Category BODY AND ACCESSORIES	Technical Service Bulletin - Repair Guide	Ref. No. R025/18	Page 1 / 7
Applicable Model Mazda6 (Mazda6 (GJ/GL))		Date Issued May 14, 2018	
		Date Revised Feb 26, 2021

Subject: : Mazda6 (GL) - Power Outer Mirror does not fold in

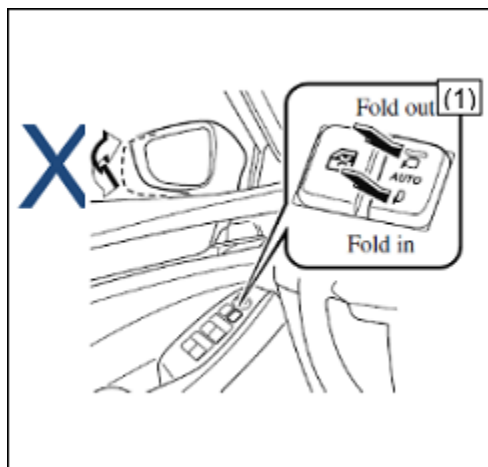
Some vehicles may exhibit a condition where the power outer mirror will not fold in and/or out when the outer mirror holding switch (1) is operated.

MASS PRODUCTION CHANGE

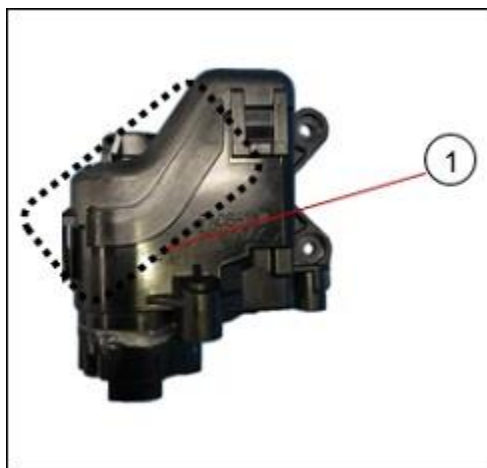
1. Overlapping part of the water-proof sealing inside the electric fold-in unit (it cannot be seen from outside) has been extended. Also, flange (1) has been attached instead of a water proof seal.

2. The height of the mirror frame rib has been changed.

3. Material of the washer has been changed and another washer has been added to the shaft.
